**FINAL ENVIRONMENTAL IMPACT REPORT
MODIFICATIONS TO EXISTING (YEAR 2005)
CONDITIONAL USE PERMITS –
ALTAMONT WINDS INC. (AWI)**

**State Clearinghouse #2012062060
July 2013**

ICF International. 2013. Final Environmental Impact Report, Modifications to Existing (Year 2005) Conditional Use Permits – Altamont Winds Inc. (AWI). July. (ICF 00277.12.) Sacramento, CA. Prepared for County of Alameda, CA.

Exhibit A
 AWI Average Monthly Focal Species Fatalities (unadjusted)

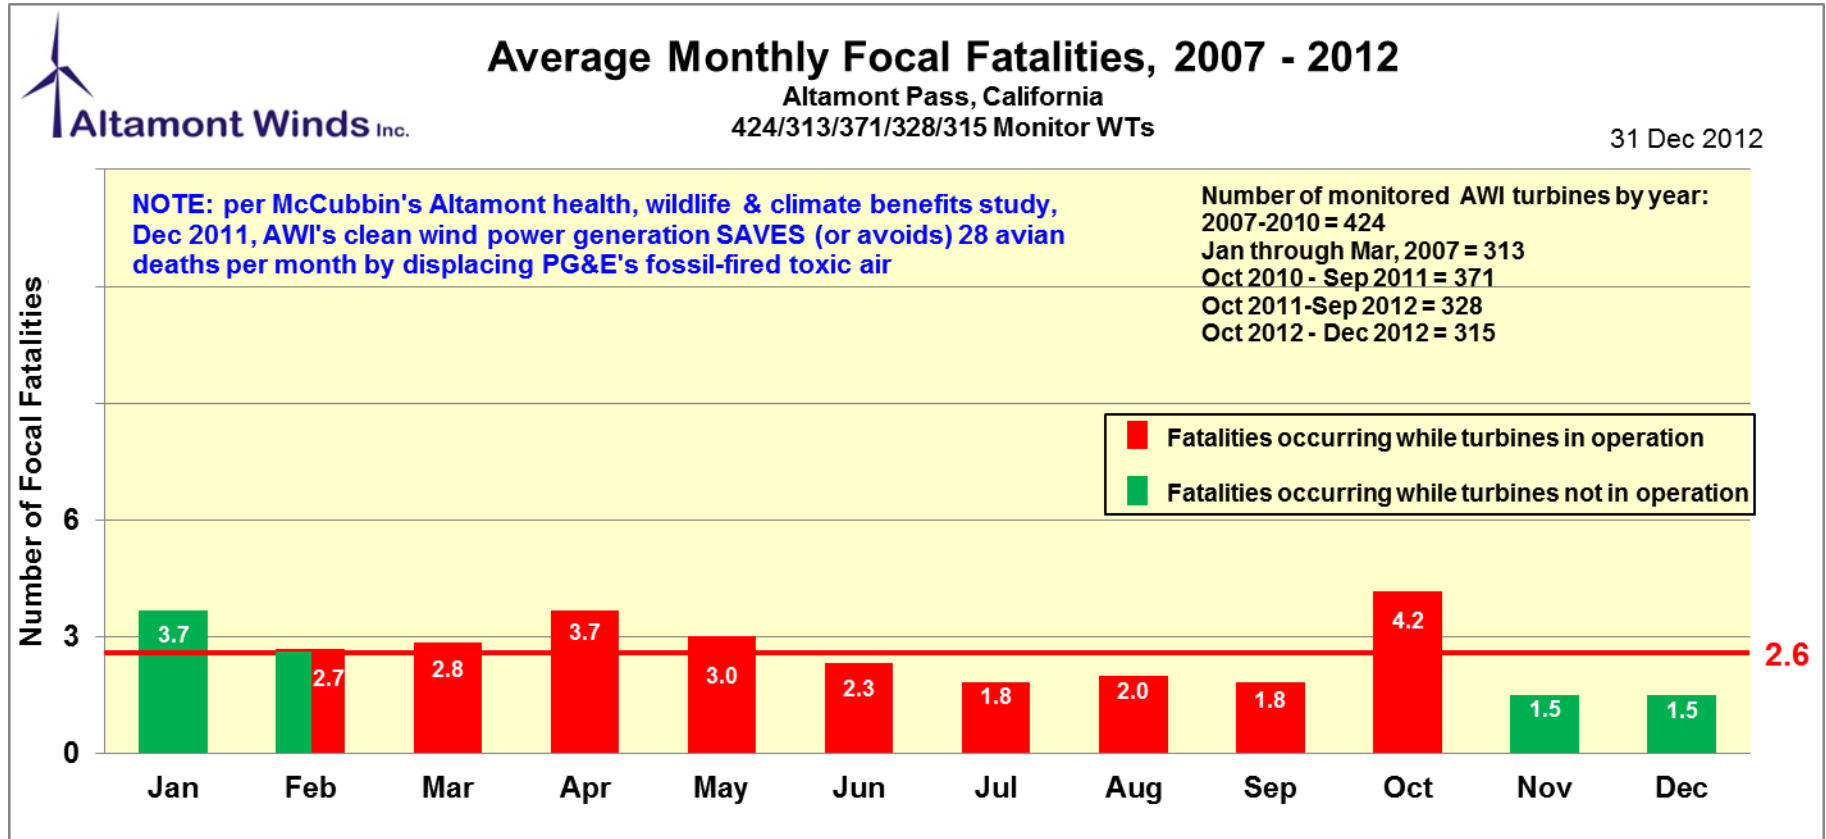
O4-36
cont.

Revised Figure 2-2
Project Site and Facilities

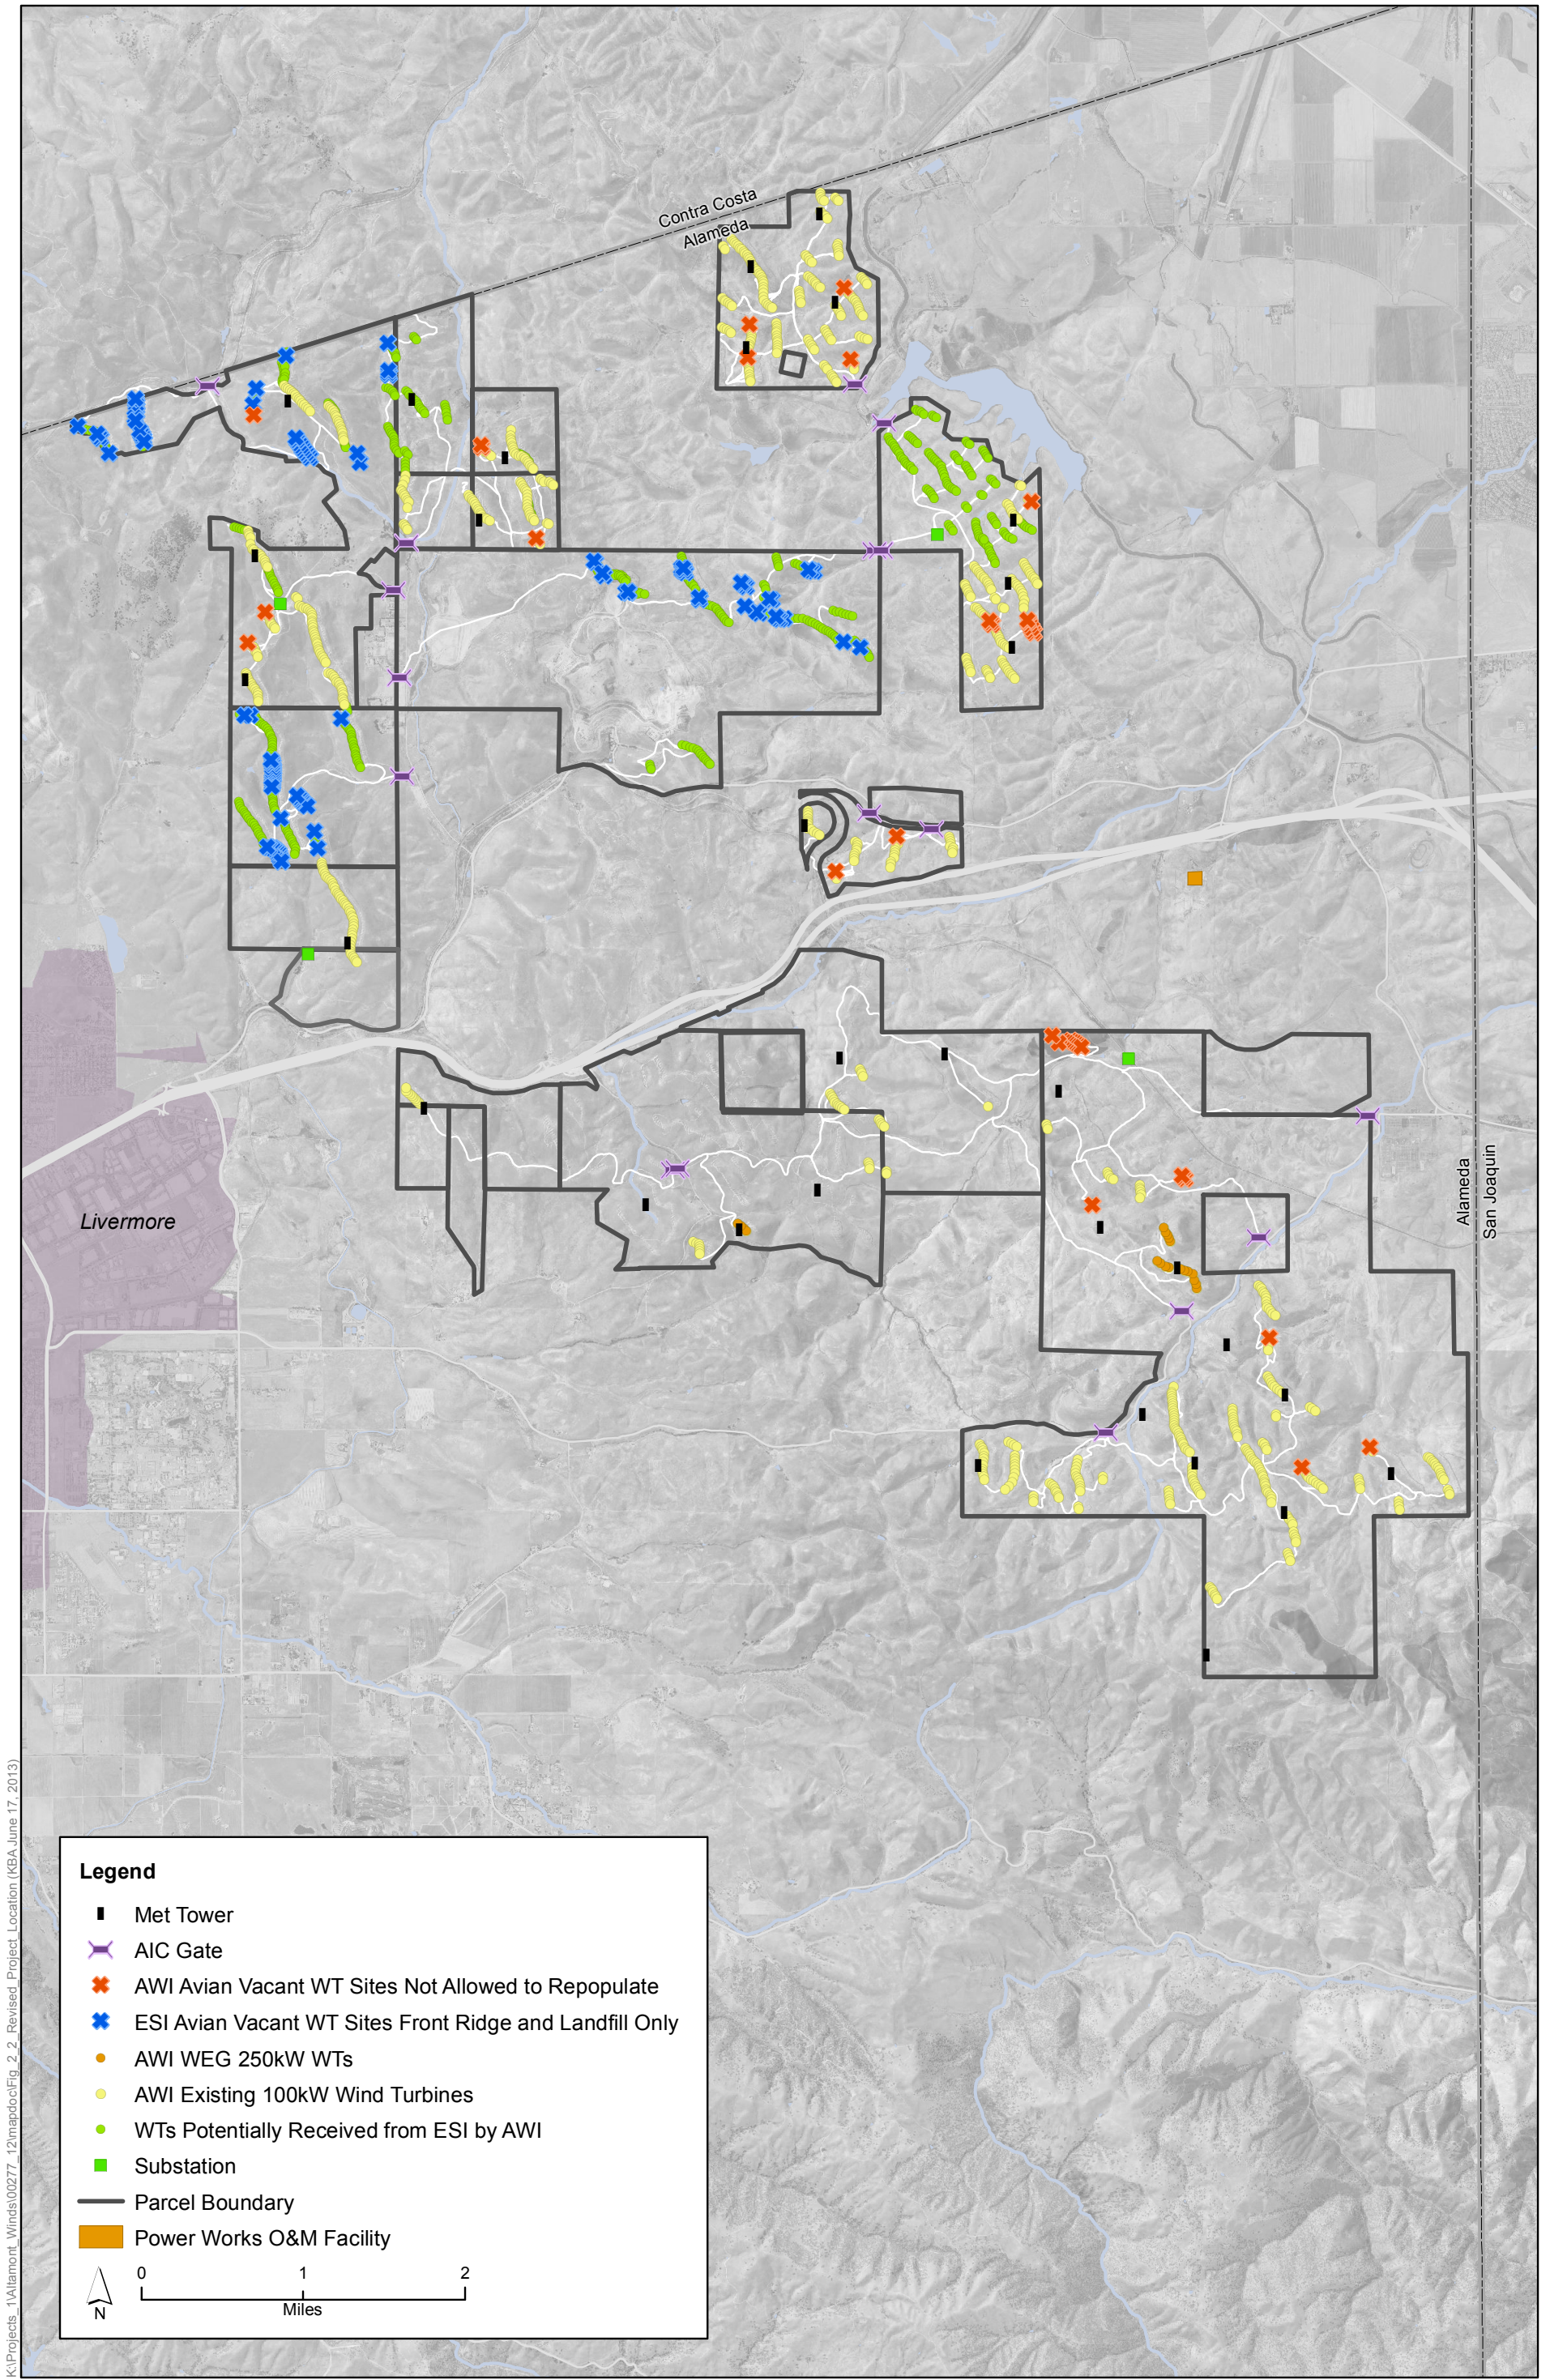
4. Correct the mislabeling in Figure 2-2. In the legend of Figure 2-2, the label associated with the green dot should read “WTs Potentially Received from ESI by AWI.” The turbines currently shown as green dots are not currently AWI assets but may be in the future depending upon discussions with ESI/Green Ridge Power (an unaffiliated wind farm operator in Altamont Pass) regarding assets in the Altamont Pass.

The commenter points out an error in Figure 2-2 of the draft EIR. Figure 2-2 has been corrected; please see Chapter 4, *Draft EIR Errata*, of this final EIR. The text of Section 2.3.2, *Description of Project Area*, has been revised to reflect the requested clarification. This additional text does not affect any of the impact conclusions in the EIR.

Following page 2-8, Figure 2-2 has been revised.
